REF NO.	AT03224
DATE	Nov. 21, 2003
(C)	Page 1 of 5

SUBJECT: IMPROVED TORQUE CONVERTER STATOR BUSHING

PURPOSE: To introduce improved torque converter stator bushings

APPLICATION: HD465-7 Dump Trucks, Serial Nos. 7001 thru 7124, 7126 thru 7130

2. List of parts

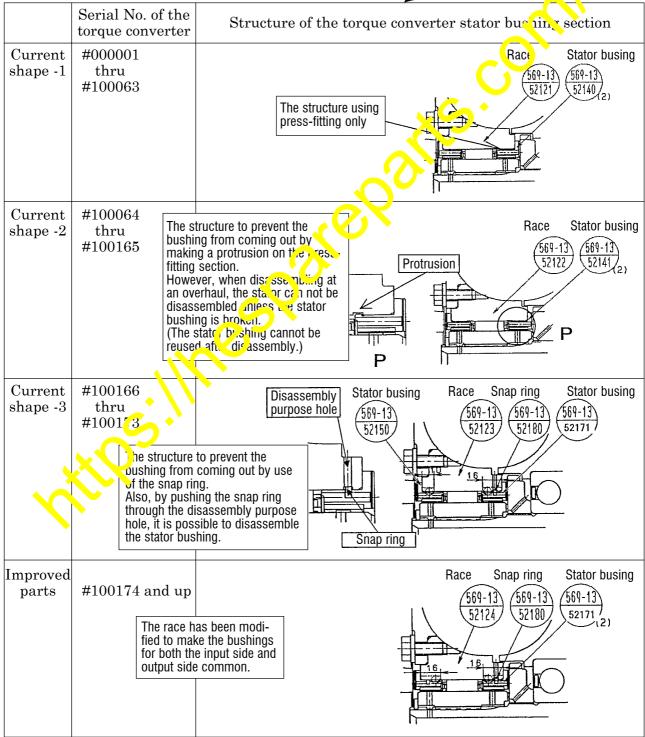
KOMATSU has developed improved torque converter stater bus lings which will not come out even under severe operating conditions which cause the torque converter to stall frequently for use on the HD465-7 and HD605-7 dump trucks, and is introducing these improved new parts in this Service News.

Cross-sectional view of the torque converter

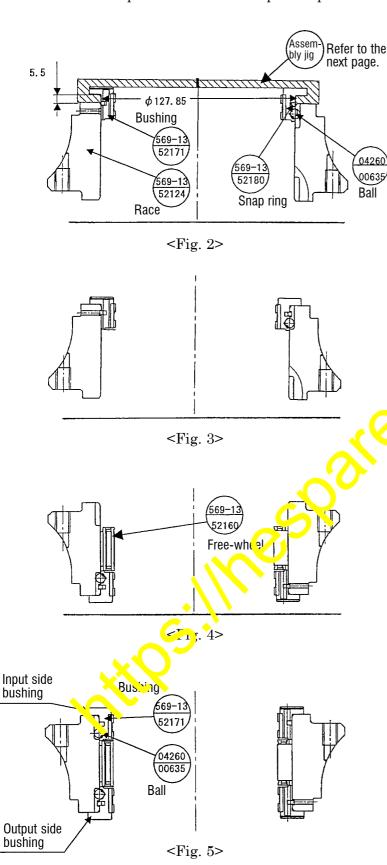
As shown in the drawings below, a snap ring has been added to the stator bushing section so that the stator bushing may not come out, and at the same time, convenience for disassembly work when carrying out an overhauling is also being secured.
